MONTGOMERY COUNTY HISTORIC PRESERVATION COMMISSION
STAFF REPORT

Address:	10304 Kensington Parkway, Kensington	Meeting Date:	5/14/2025
Resource:	Primary Resource Kensington Historic District	Report Date:	5/7/2025
		Public Notice:	4/30/2025
Review:	HAWP	Tax Credit:	No
Permit Number:	1114379 & 1114415	Staff:	Dan Bruechert

PROPOSAL: Construction of accessory building, fencing, and associated hardscape

Figure 2: Approved site plan for the accessory building (left) and the expanded accessory building (right, expansion outlined in blue).

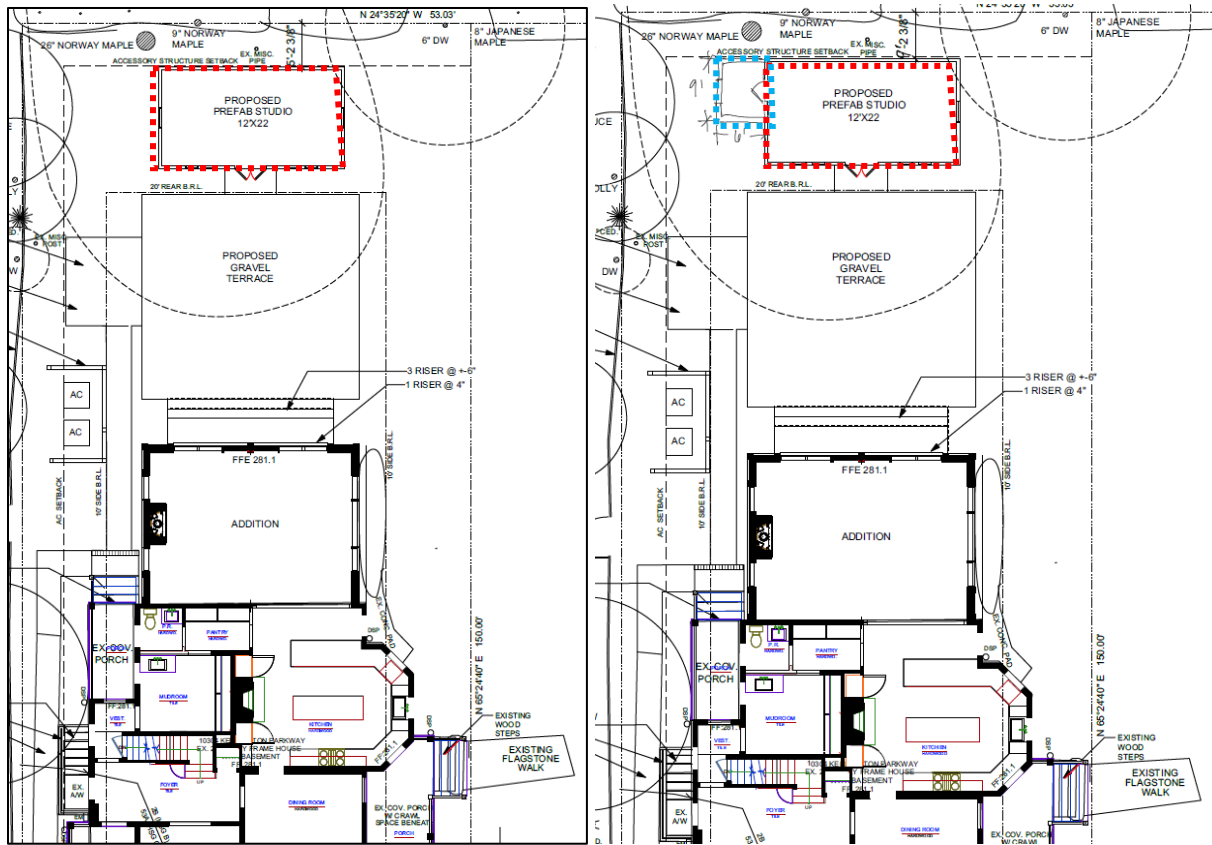
The applicant proposes to expand on the approved design with a 6' × 9' (six foot wide by nine feet deep) bump out on the south side of the proposed structure (see *Figure 2*, below). The proposed bump out as the same German siding in a 6" (six inch) reveal), with a cedar shake roof. The ridge of the bump-out roof is 1' 1" (one foot, one inch lower than the ridge of the larger pre-fab structure. The only fenestration proposed for the bump-out is a wood six-over-six sash window on the south elevation.

Figure 4: The location of existing trees in relation to the proposed accessory building. The red arrow points to the two subject trees.

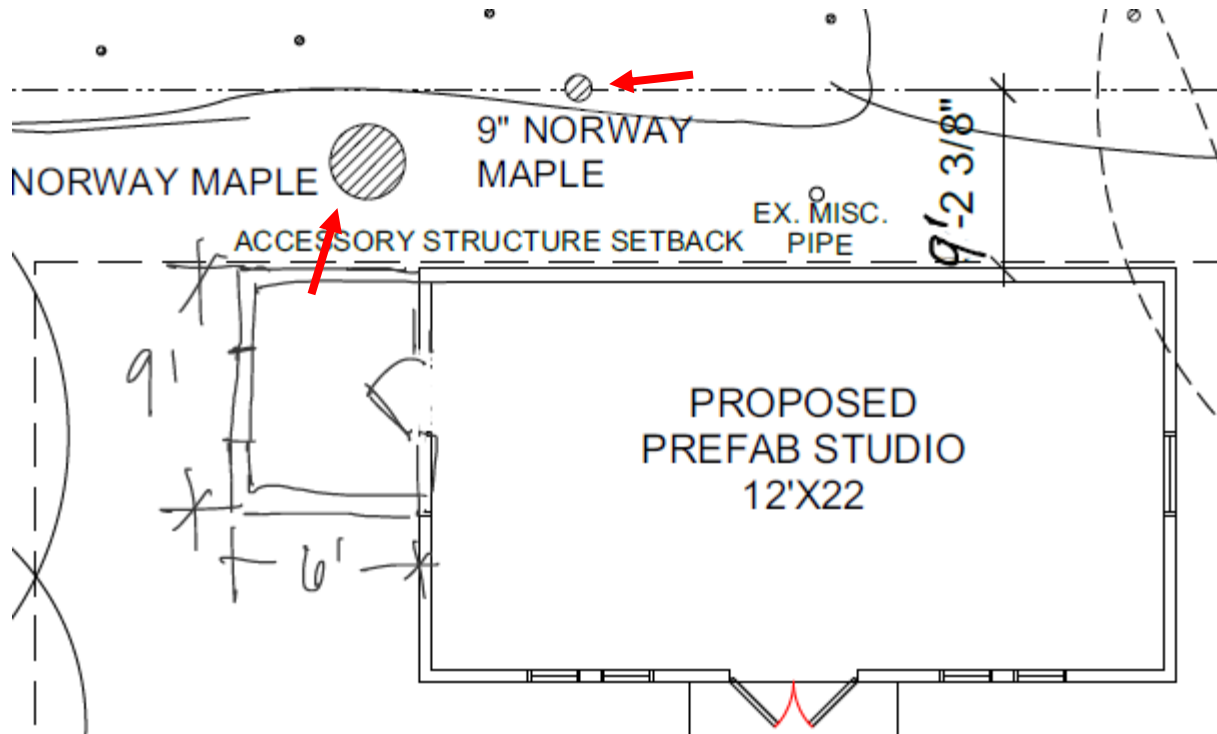
Staff requests additional information about the protection of a 26" Norway Maple and 9" Norway Maple near the proposed accessory building (*Figure 4*). The proposed concrete slabs is 4" (four inches) thick, which could adversely affect the health of the trees. The prior approval included a condition requiring the applicant to submit an arborist report analyzing the potential impacts of the structure. Staff finds the expanded footprint of the proposed structure is closer to the Norway Maple Staff than the prior approval and recommends the HPC carries over the condition requiring an arborist report detailing the impact, specifically, to these two trees. These recommendations would be reviewed and approved by staff who could require mitigation (planting of new trees) if deemed appropriate.

2. The applicant must submit specifications for all proposed lighting.
3. The applicant must provide an arborist report regarding any required tree protection for the installation of a new concrete or gravel pad. Of particular concern is the 26" and 9" Norway Maples to the southwest of the proposed accessory building.

Figure 5: Proposed HVAC and trash enclosure (left) and proposed gravel terrace (center).

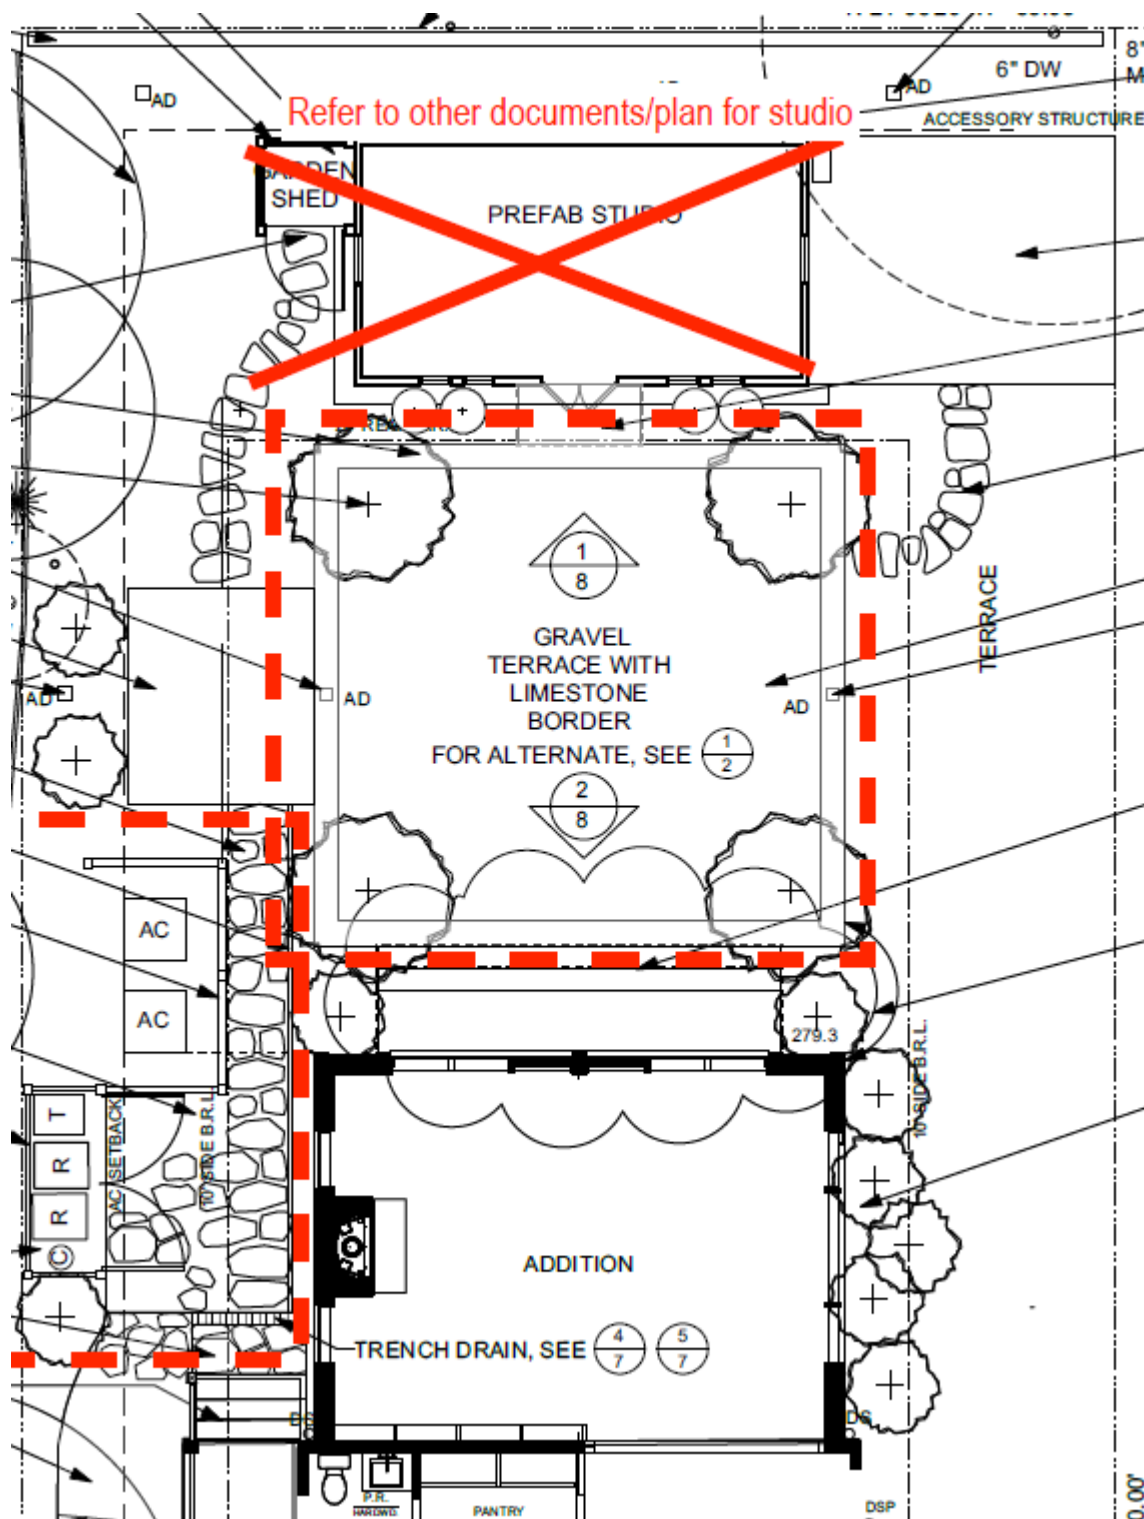
On the left side of the house, adjacent to the approved rear addition, the applicant proposes to install two areas of fencing (see *Figure 5*, below). The HVAC enclosure will be a solid wood board fence, 5' (five feet) tall, with cedar top and bottom rails. The enclosure measures approximately 5' × 10' (five feet wide by ten feet deep) and is open on the south side, facing out of the property towards the neighboring property. The trash enclosure is also 5' (five feet tall) and approximately 9' × 4' (nine feet wide by four feet deep) and is the same solid board fence as the HVAC enclosure. The trash enclosure has a pair of 4' (four foot wide) doors on the north side with contemporary-style black metal hinges.

Staff finds the size, materials, and design are all compatible with the character of the site and surrounding district. While the HPC typically requires open picket fences in front of houses in the Kensington Historic District, these fences are both behind the historic rear wall plane and Staff finds they will not interrupt the district's garden suburb character. Staff would generally recommend against an HVAC enclosure that is open towards the neighboring property, however, the neighboring property is a triple lot and the nearest house is more than 125' (one hundred twenty-five feet) from the subject property. Staff finds the proposed fences are compatible with 24A-8(b)(2) and (d), *Standard* #2, and 10, and the *Vision of Kensington*.

The last change proposed in this HAWP is the construction of a gravel terrace with a limestone border located between the approved rear addition and the proposed accessory structure. The terrace measures 25' x 25' (twenty-five feet square) and will be comprised of 2" (two inches) of gravel over a 4" (four inch) bed. The gravel terrace is located entirely behind the historic house, on grade, and will not be at all

Staff finds the proposed gravel terrace is compatible in design and materials with the character of site and surrounding garden suburb. Staff finds the terrace will not overwhelm the existing landscape or built elements on site. Additionally, Staff finds the terrace could be removed in the future and return the back yard to its current condition, consistent with Standard 10. Staff recommends the HPC approve the terrace under 24A-8(b)(2) and (d), *Standards #2 and 10*, and the *Vision of Kensington*.
